TOWN OF COVENTRY, RI
DEPARTMENT OF PLANNING & DEVELOPMENT

STAFF REPORT

Project Name:	Village at Tiogue
Plan Type:	Comprehensive Permit / Major Land Development
Plan Review Phase:	Preliminary Plan
Owner/Applicant:	232 Realty Associates
Address:	Tiogue Avenue, Tiffany Road, East Shore Drive, & Minglewood Drive
Plat / Lot / Zone:	AP 32 Lots 149, 150, 151, & 153 Zone R-20 Lot Size 26.99 acres
Existing Use:	Vacant / Open Space
Proposed Use:	162 Single- and Multi-Family Units
Description:	The applicant has submitted a <i>revised</i> Preliminary Plan submission to develop 162 units comprised of a mix of single-family units and multi-family units on approximately 27 acres of land as a Comprehensive Permit. A minimum of 25% of the proposed units must be deed-restricted as affordable. Site access is proposed from Tiogue Avenue, Tiffany Road, East Shore Drive, and Minglewood Drive. Public water and sewer access to the development is anticipated.

Figure 1. "Village at Tiogue" – Area 1 Site Plan

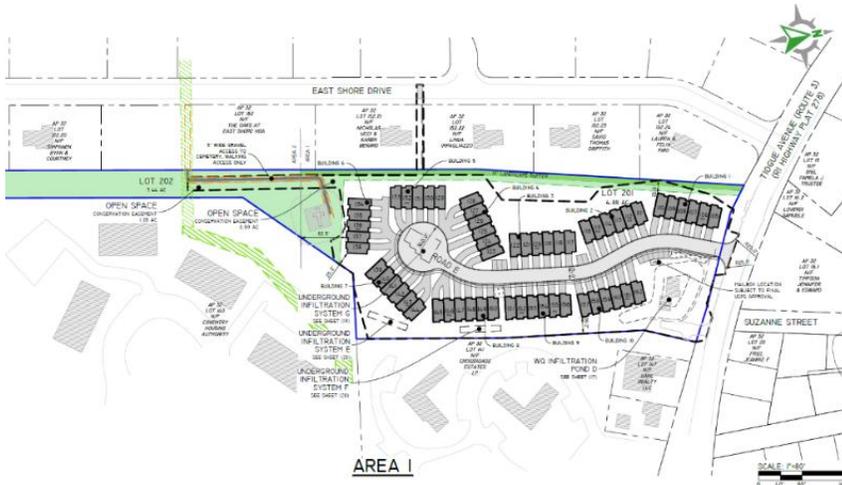
The applicant's revised Site Layout Plan depicts the proposed through-road connection between Areas 2 and 3 (as shown in Figure 2 above). The applicant's traffic engineer and the Town's peer reviewer agreed that the proposed through-road will result in a negligible impact on trip distribution. The revised plan also proposes additional sidewalks in Area 1, along the eastern side of Road E. These site plan changes are consistent with the peer reviewer's recommendations and satisfy prior TRC comments and Planning Commission feedback for these specific issues.

Figure 4. Tiffany Road Widening Plan – Eastern Section

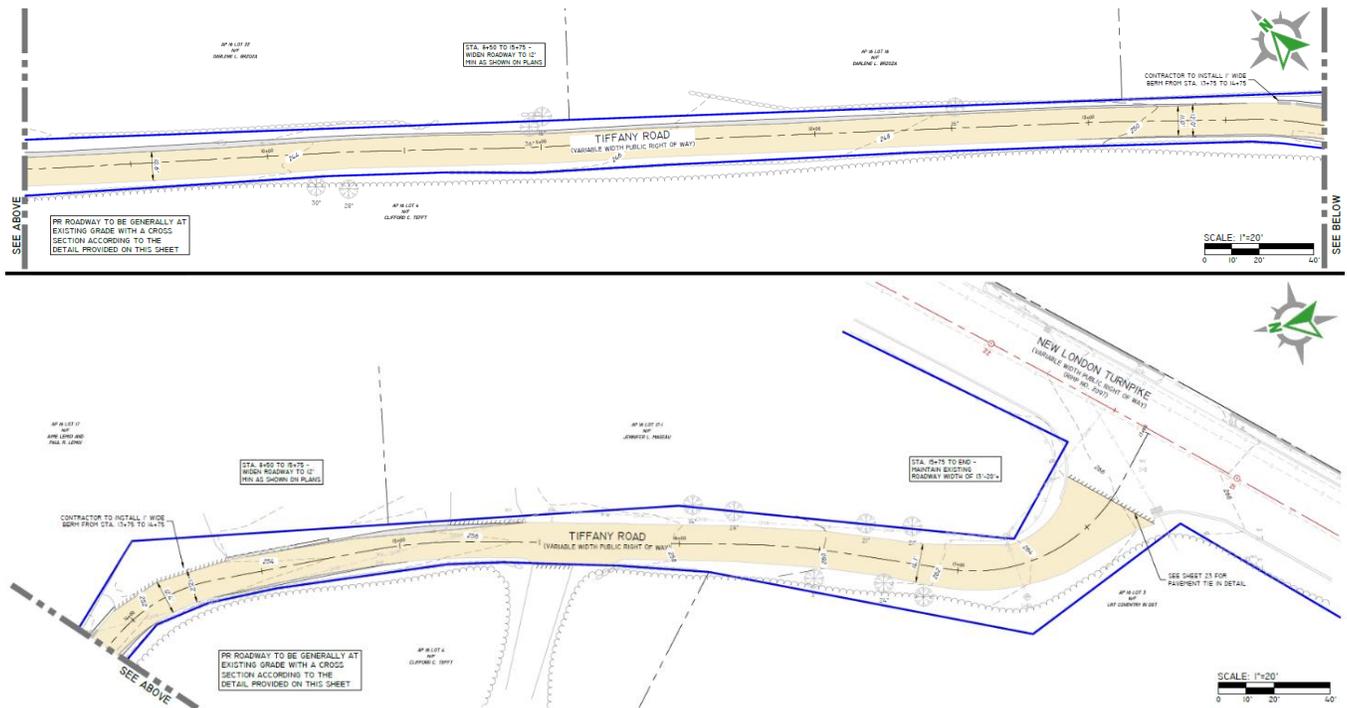
Furthermore, the "eastern" section of Tiffany Road, from Old North Road to New London Turnpike, will be improved to 12' pavement width to ensure safe one-way passage, improved with new asphalt, and

cleared of select vegetation (as shown in Figure 4 above). DiPrete Engineering, the applicant's civil engineer, provided staff with a letter regarding the proposed widening of Tiffany Road, dated January 19, 2026, which states that the proposed 12' width in the eastern section "represents the maximum practicable improvement within the existing right-of-way." The letter cites right-of-way constraints, boulder walls and demarcated boundaries, and topographic constraints as limitations on further widening. The applicant's engineer also stated that a 1-2' shoulder will be provided where conditions allow and that additional tree removal can be performed at the Town's request. The Town's peer reviewer updated letter dated January 16, 2026 found the proposed 12' width to be acceptable for future travelers and emergency vehicles. Planning Staff, relying upon the expertise of the peer reviewer, concur with Fire District representatives and the Police Department that the widening of Tiffany Road has adequately addressed emergency access challenges.

11. The applicant’s Tiffany Road Widening Plan (Sheet 28) is consistent with the Peer Review Report’s initial recommendations. The “western section” of the road, from the site access road to the intersection with Old North Road, will be improved to 22’ pavement width and “eastern section” of the road, from the intersection with Old North Road to the terminus at New London Turnpike, will be improved to 12’ pavement width. The applicant’s engineer found that 12’ was the maximum practicable width for that section given the right-of-way constraints. The updated peer review letter, dated January 16, 2026, states that “this width will provide enough accommodations for vehicular traffic and emergency vehicles ... The roadway width proposed is acceptable but the developer should coordinate with the Town regarding tree removals and other improvements, if necessary.”
